AGENDA ITEM #12

Application for: Preliminary Plat

Location: Ridgway USA Subdivision, Lots 30-34

STAFF REPORT

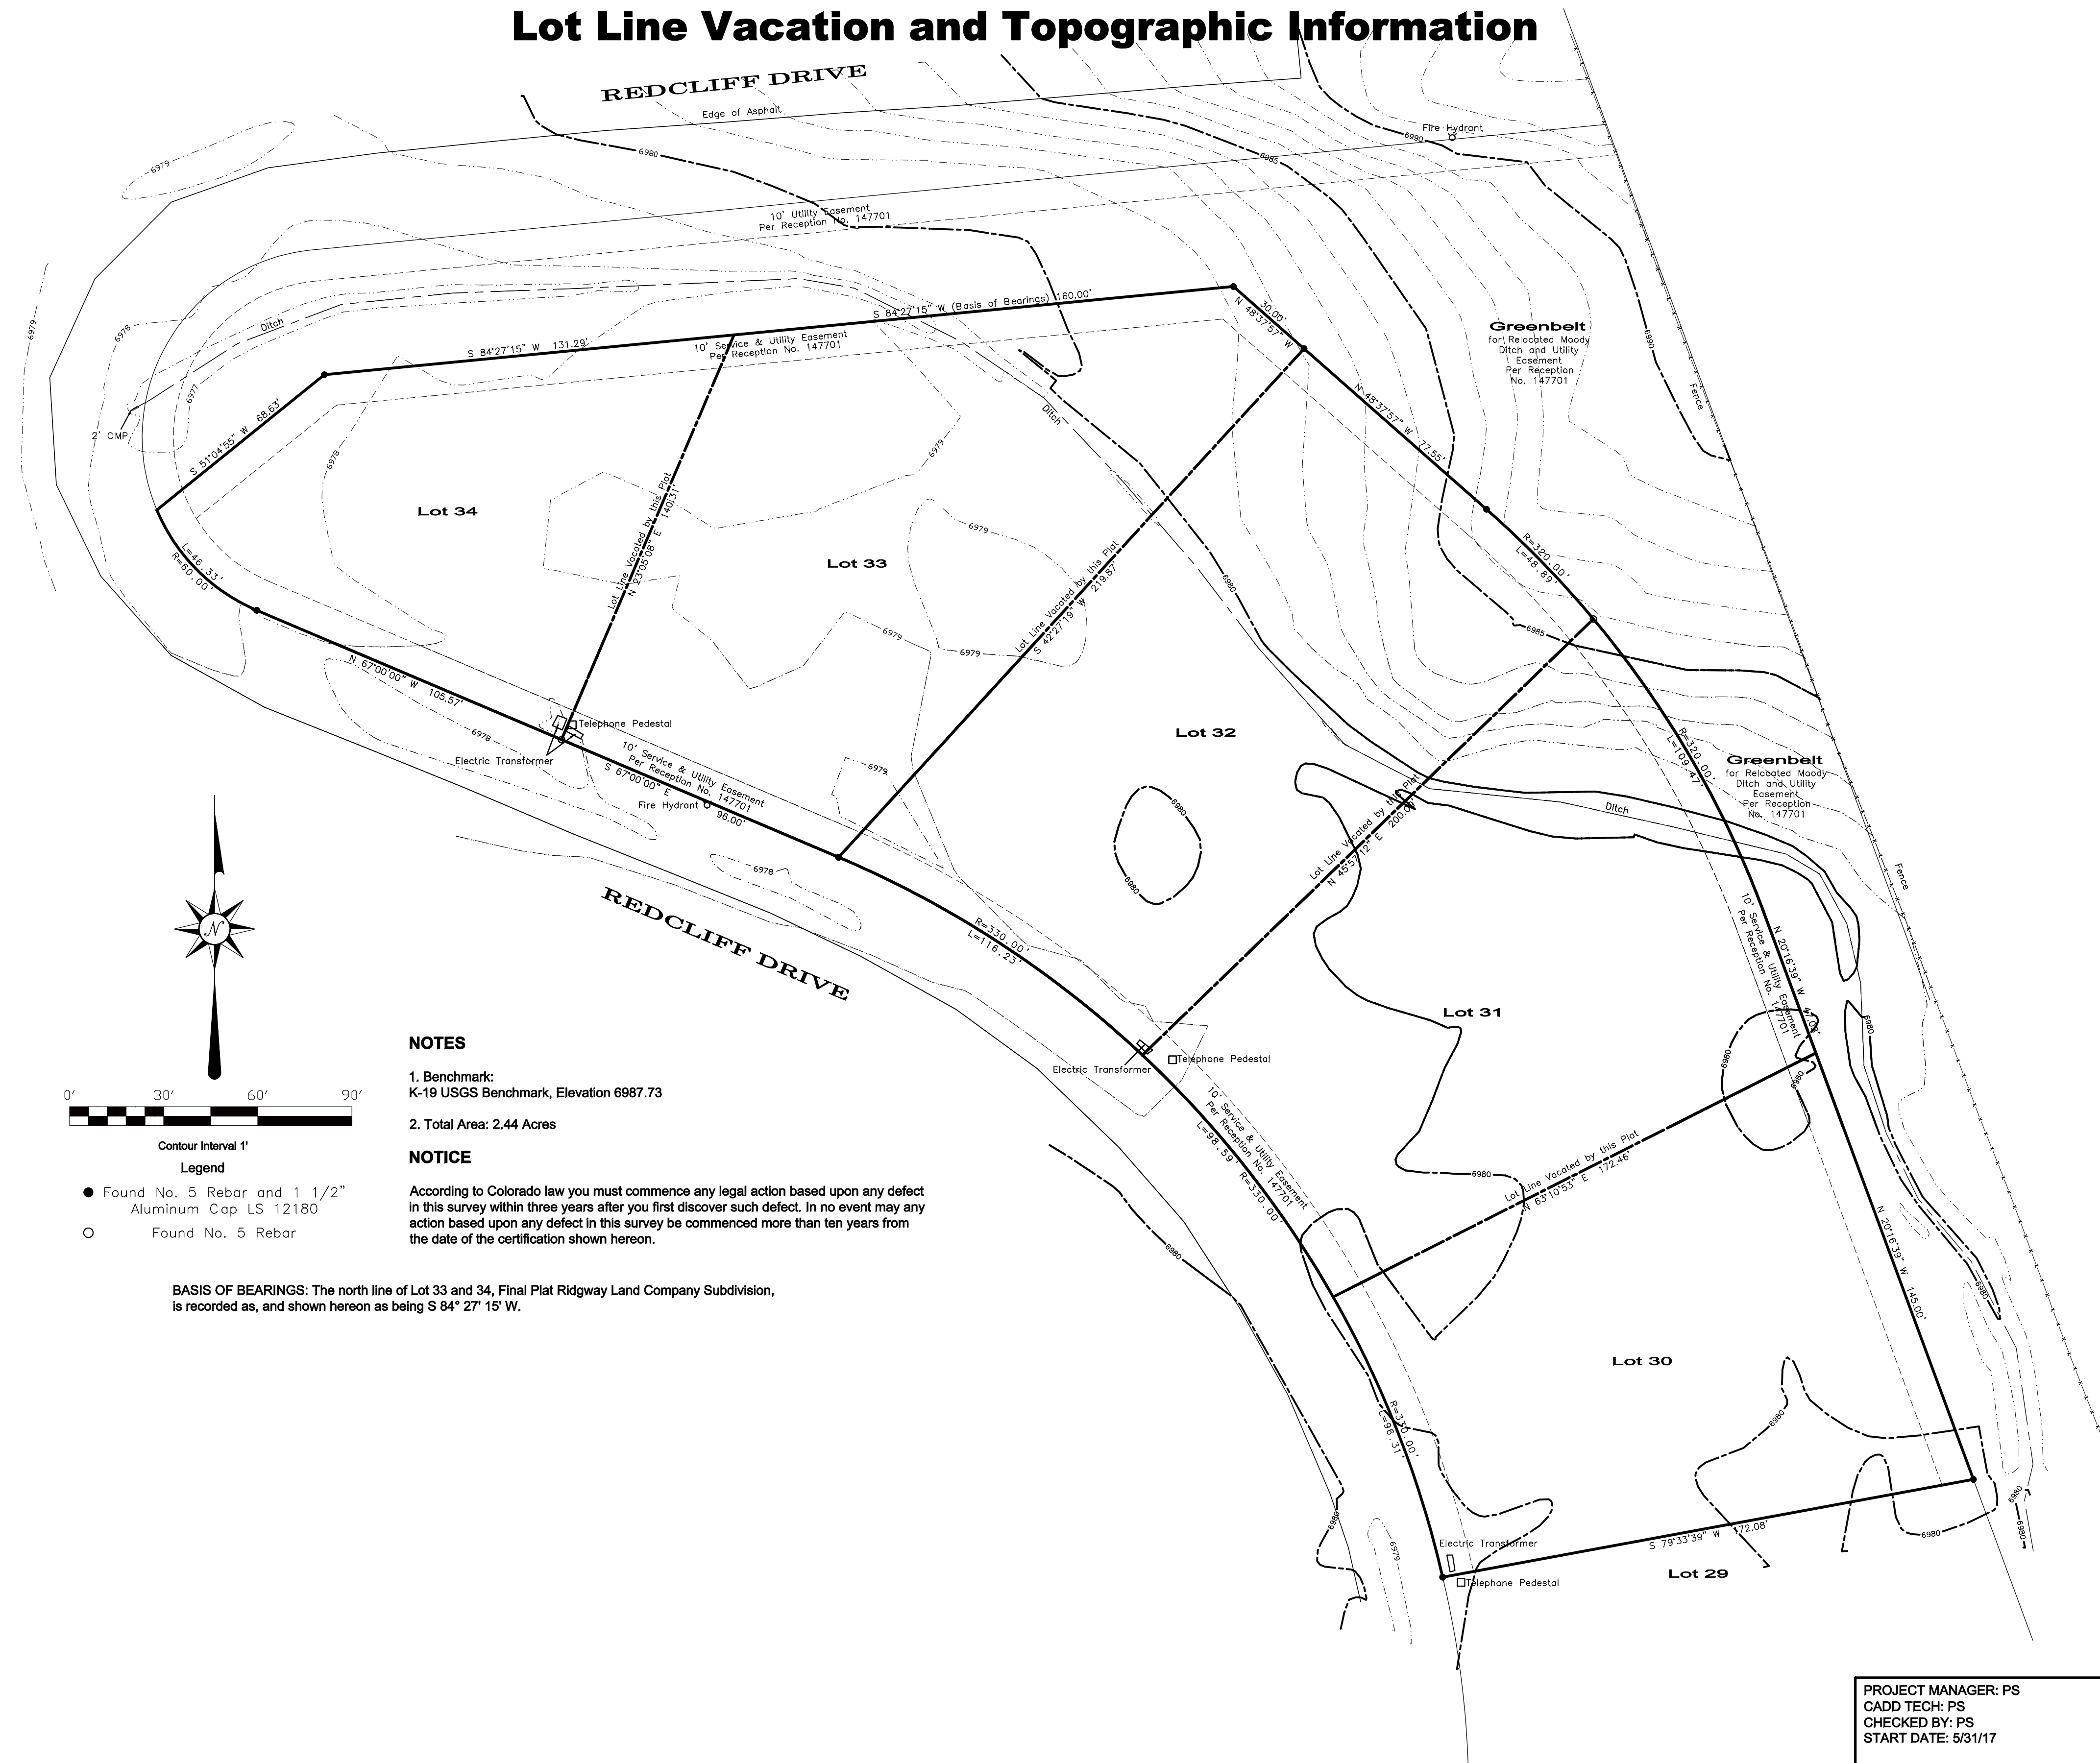
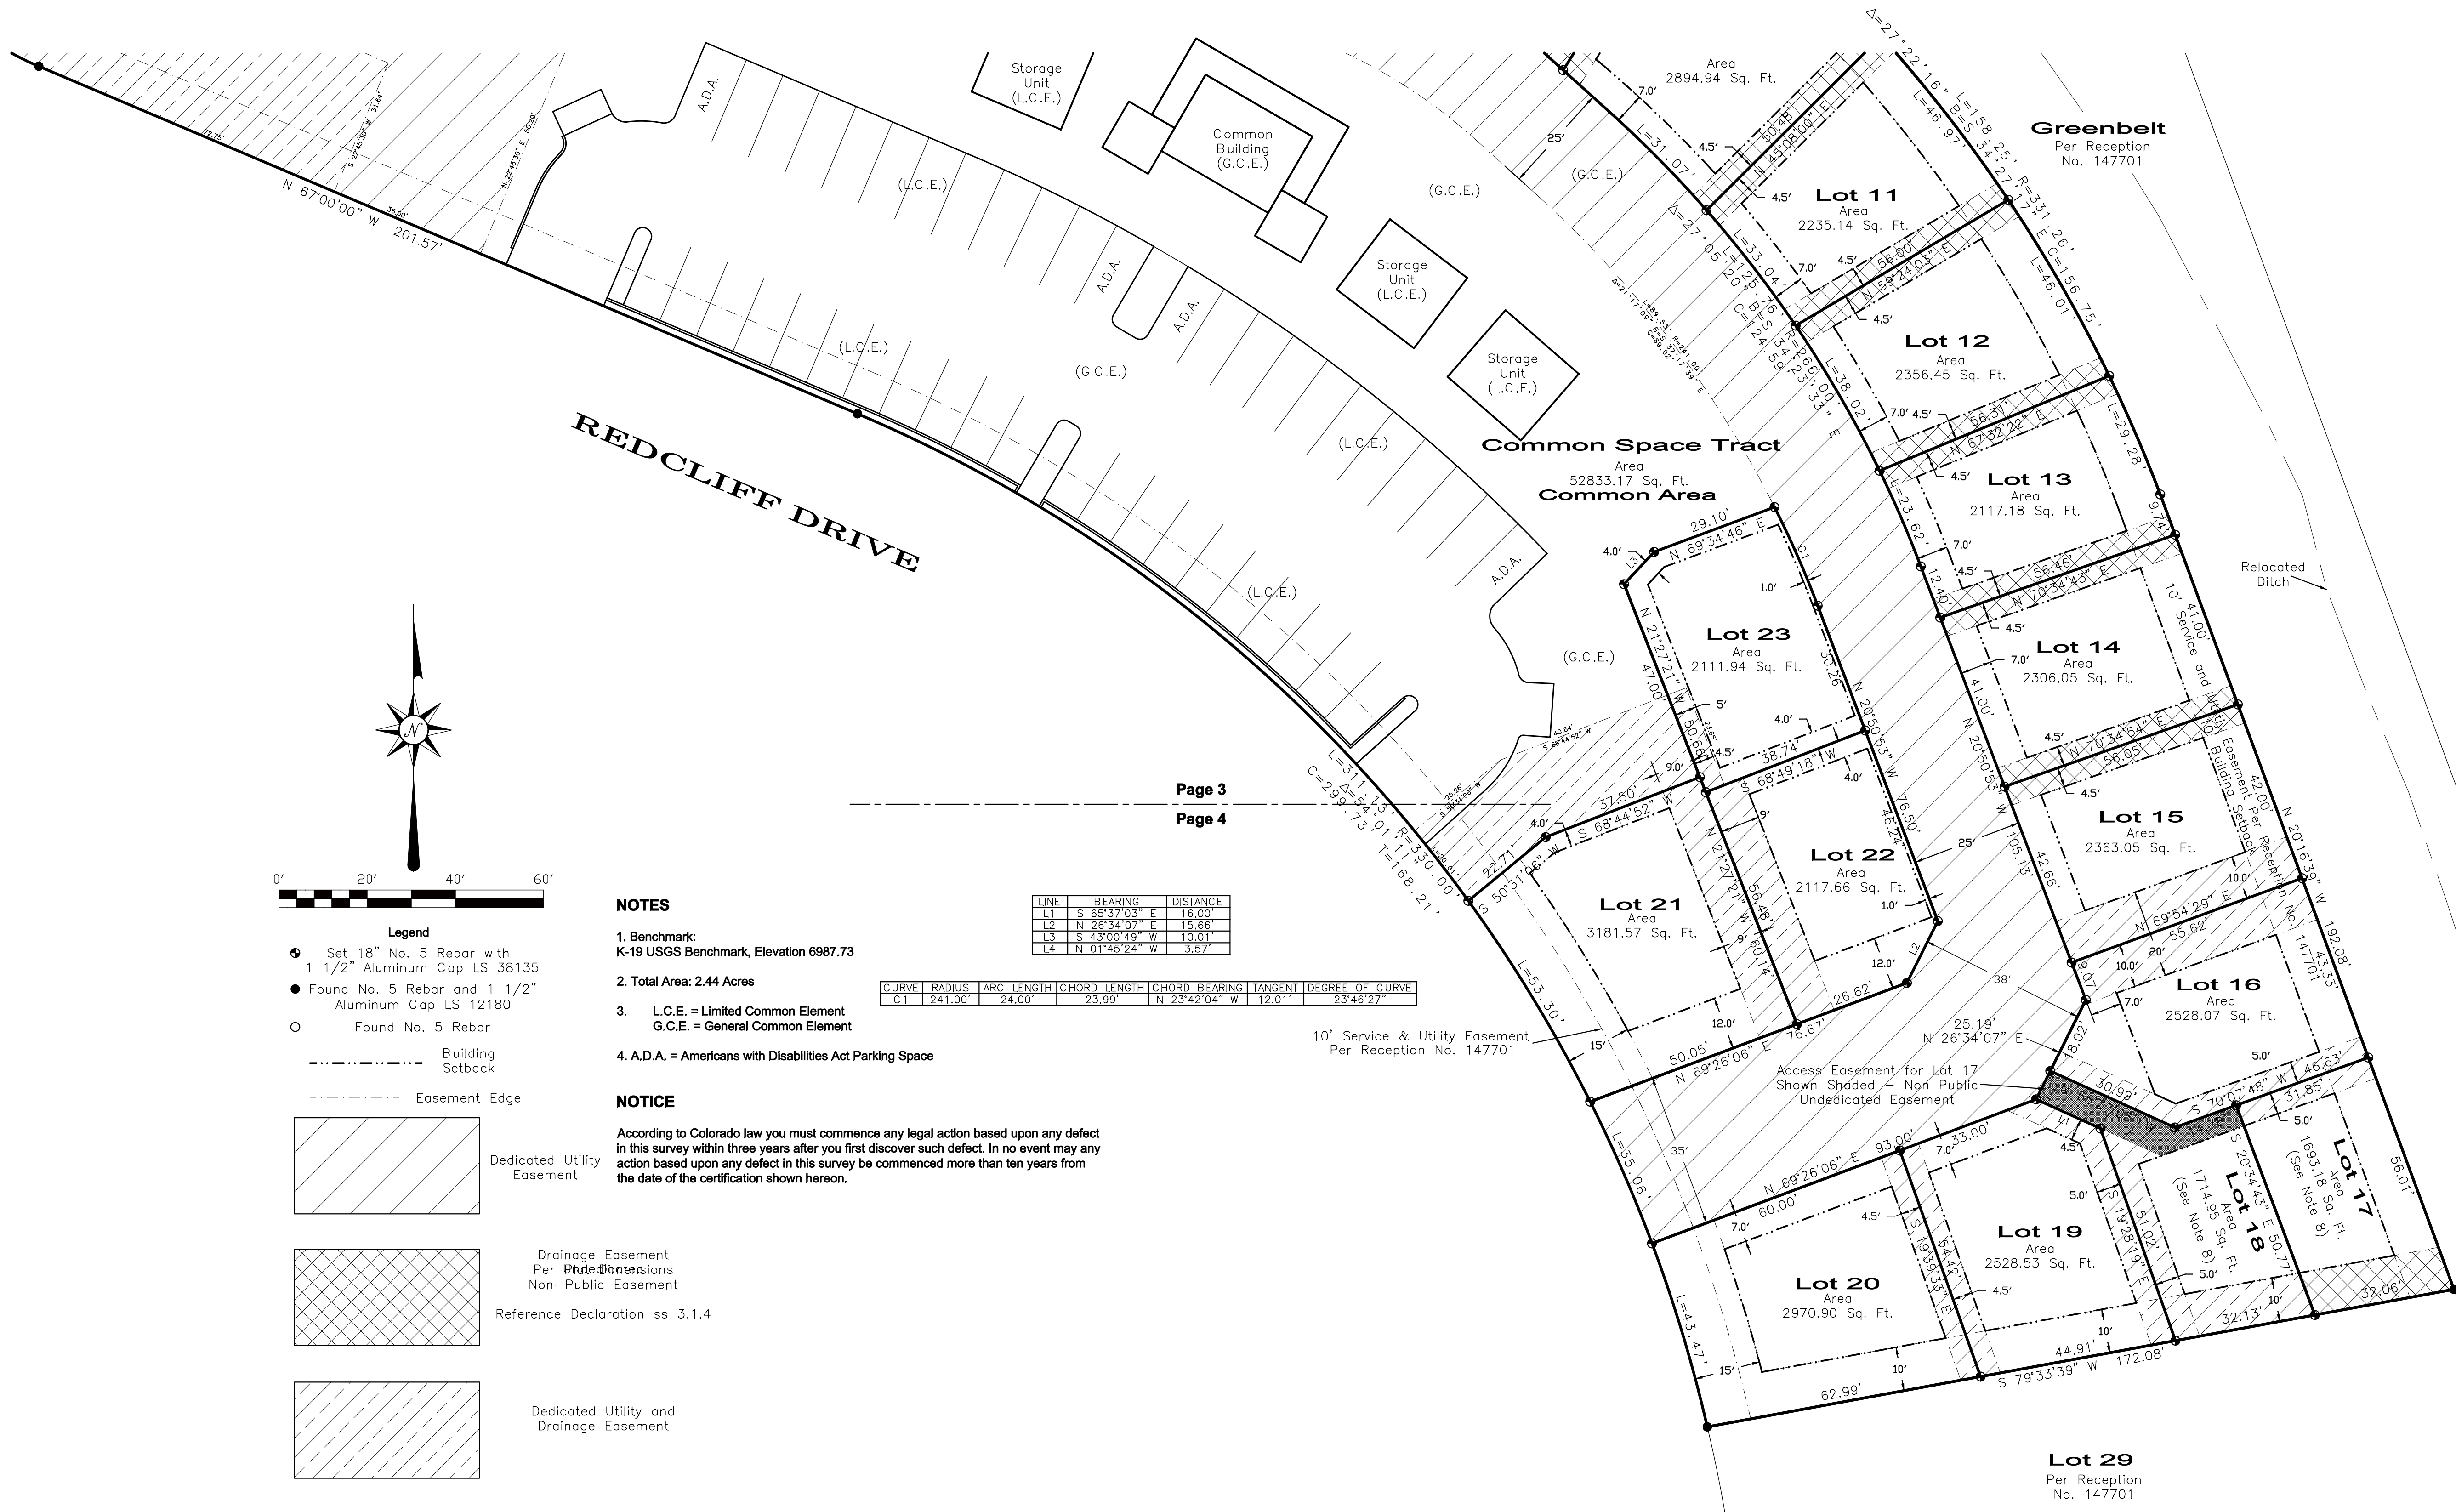
- The easements and dedication language on the plat need to be cleaned up. These easements should also be reflected the same on the civil plans. Some things that need to be looked at include:
 - The “Dedicated Utility and Drainage Easement” between lots 15 and 16 does not seem to be dedicated to the Town and there is a sewer main going through that easement area.
 - The “Dedicated Utility and Drainage Easement” north of lot 21 is to access a sewer main running between lots 21 and 21. Not sure that it is properly dedicated to the town.
 - What is 4(ii) “Service and Utility Easements”? I do not see that on the map.

Need dimensions, bearings, distances, etc. for the relocated ditch on pages 3 and 4 of the plat map. Also ensure it matches the civil plans.

Need to delete the setback lines that continue beyond where needed on lots 18-21.

- Page 4 of the plat- delete extra word under drainage easement the key.
- Regarding the Redcliff Drive ROW
 - On the curb and gutter typical drawing, please clarify what slope and width of the gutter is proposed.
